ALERT SERVICE BULLETIN

212-18-160  
25 September 2018

**MODEL AFFECTED:** 212

**SUBJECT:** HANGER BEARING SUPPORT BRACE ASSY 205-030-831-015 INSTALLATION, VERIFICATION OF

Figure 1.

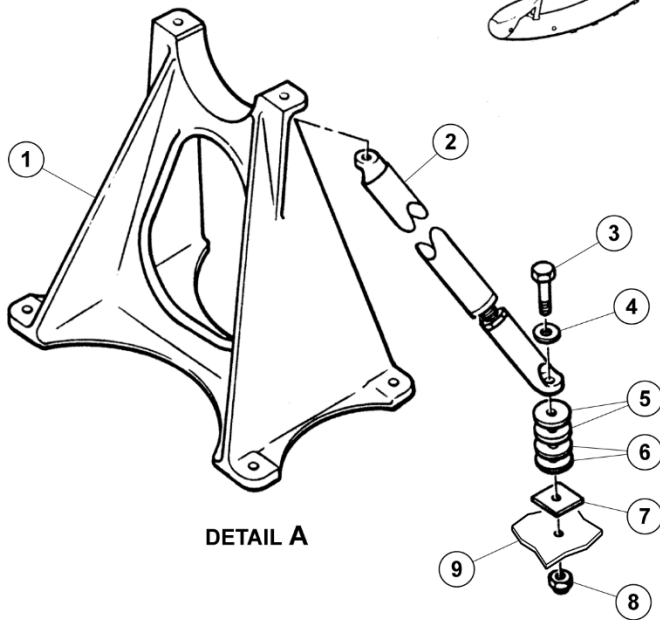
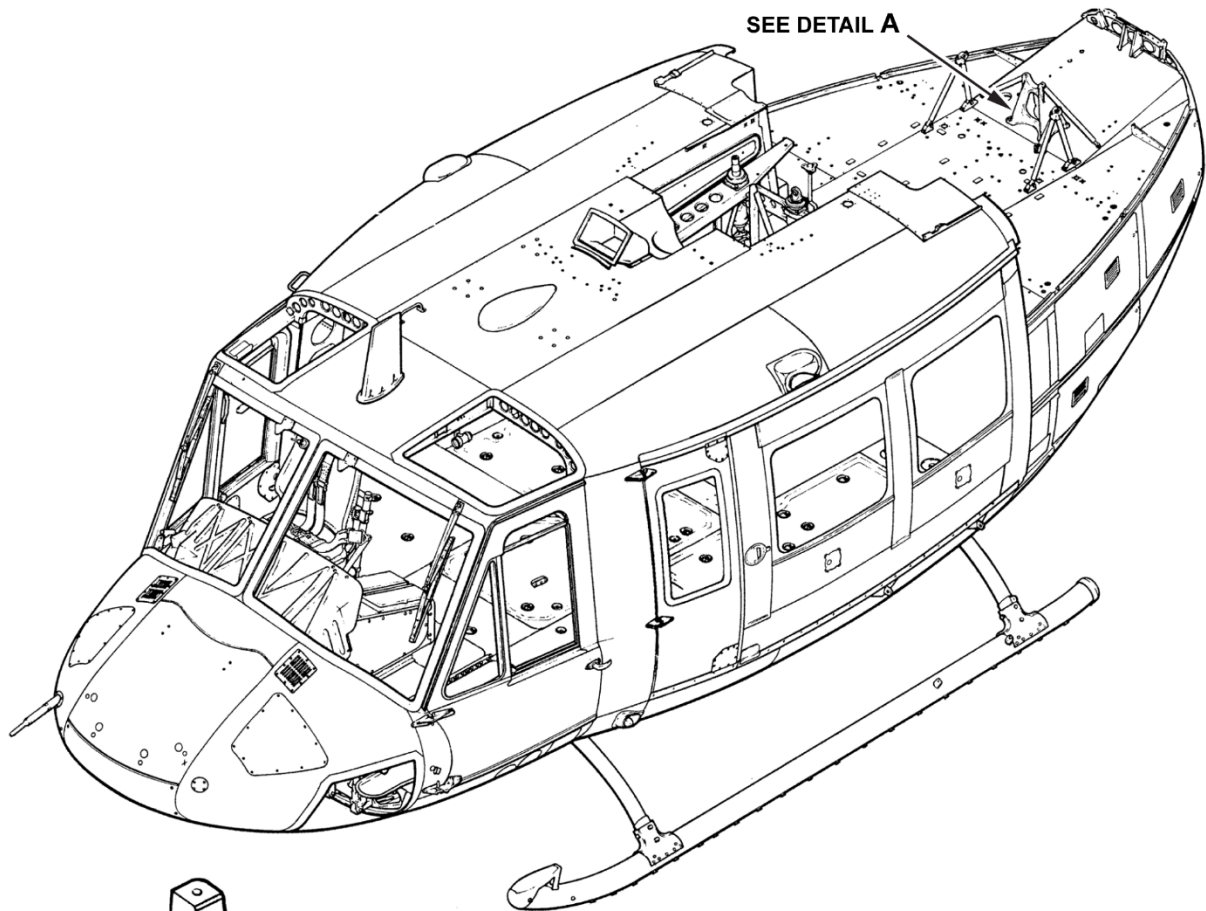
1. Prepare the helicopter for maintenance.
2. Gain access to the tail rotor driveshaft hanger bearing support (1, Figure 1) and locate brace assemblies (2).

3. Check installed brace assemblies (2) for preload condition. Remove Sealant. Remove bolts (3) attaching brace assemblies (2) to service deck (9). If brace assembly (2) is properly adjusted, there will be no spring-back or hard contact with

the service deck (9) when bolts (3) are removed. If spring-back is in excess of 0.020 in., or hard contact is evident, adjust brace assemblies (2) as follows:

- a. Adjust overall length of brace assembly (2) so that the bolt holes in the brace lower fitting and service deck (9) are aligned.
- b. Adjust thickness of peel shims (5 and 6) between lower ends of brace assemblies (2) and service deck (9), so there is no excessive spring-back or hard contact (preload).

Maximum amount of laminated shim permitted is 0.374 inch. If more shim is required, an aluminum block that can be locally fabricated and bonded to the service deck will be required. Do not exceed a total of 0.500 inch, combined laminated shim and aluminum shim block.

- c. If required, fabricate and bond aluminum block (7) as follows:
  - (1) Fabricate shim block from aluminum with dimensions as follows:
    - (a) 1.0" wide by 1.0" long by 0.250" thick
    - (b) Drill a 9/32" inch hole in center of block, deburr.
  - (2) Remove paint, dirt and primer from service deck and clean for bonding. Bond to service deck using adhesive C-317 and remove excessive squeeze-out. Allow to cure for 24 hours.
  - (3) Prime all bare metal surfaces using C-204 and allow to dry.
4. After proper brace assembly (2) adjustment and shimming have been achieved, install bolts (3) attaching brace assemblies (2) to service deck (9). Torque nuts (8) to 50-70 in.-lbs. Seal all edges using sealant C-251.
5. Make an entry in the helicopter logbook and historical service records indicating compliance with this Alert Service Bulletin.
